# Access Compliance Report

## Public Rights-of-Way

### (Curb Ramps)

Intersection ID: 20612	Main Street: ARTWOOD_LN	Cross Street: WOODKNOLL_DR	Location:	N
ADA ID: 2CF2053154FE	Ramp Type: Perp	Initial Pass/Fail: Fail	Overall Compliance: No	Severity Score: 36.25
Codes/Mitigation Info/Possible Solution		Field Measurements/Component Compliance

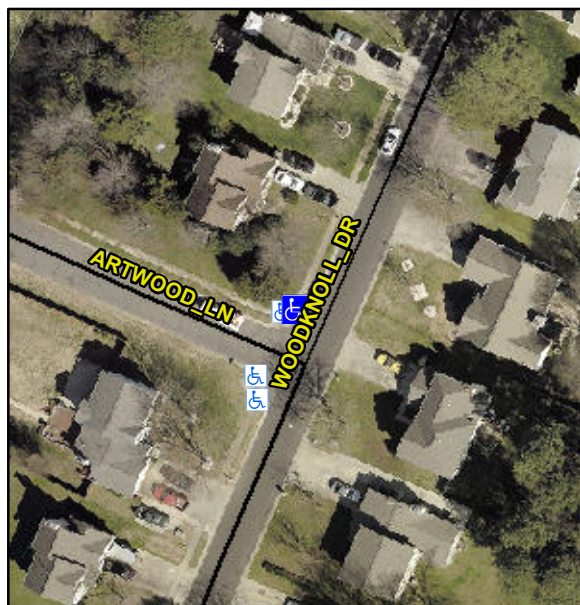
**Not Found, R304.5.1, R304.5.3**

Compliance	Description	Data	Compliance	Description	Data
N/A	Ramp Length (in)	93.0	Yes	Ramp Slope (%)	6.6
No	Ramp Width (in)	27.0	No	Ramp XSlope (%)	4.0
N/A	Flare Type LT	N/A	N/A	Flare Type RT	N/A
N/A	Flare Slope LT (%)	N/A	N/A	Flare Slope RT (%)	N/A
N/A	Flare Traversable LT?	N/A	N/A	Flare Traversable RT?	N/A
N/A	Landing Length (in)	N/A	N/A	DWS Provided?	N/A
N/A	Landing Width (in)	N/A	N/A	DWS Contrast?	N/A
N/A	Landing Slope (%)	N/A	N/A	DWS Length (in)	N/A
N/A	Landing X Slope (%)	N/A	N/A	DWS Full Width?	N/A
N/A	Landing Curb? (Y/N)	N/A	N/A	DWS Offset (in)	N/A
N/A	Shared Landing?	N/A			
N/A	Gutter Ponding?	N/A	N/A	Gutter Slope (%)	N/A
N/A	Gutter Lip Ht (in)	N/A	N/A	Gutter X Slope (%)	N/A
N/A	Painted X Walk1?	No	N/A	Painted X Walk2?	N/A
	X Walk 1 Direction	To SE		X Walk 2 Direction	N/A
N/A	X Walk 1 Width (in)	N/A	N/A	X Walk 2 Width (in)	N/A
	X Walk 1 Slope (%)	2.3		X Walk 2 Slope (%)	N/A
	X Walk 1 X Slope (%)	0.0		X Walk 2 X Slope (%)	N/A

**Remove & Replace Entire Ramp.**
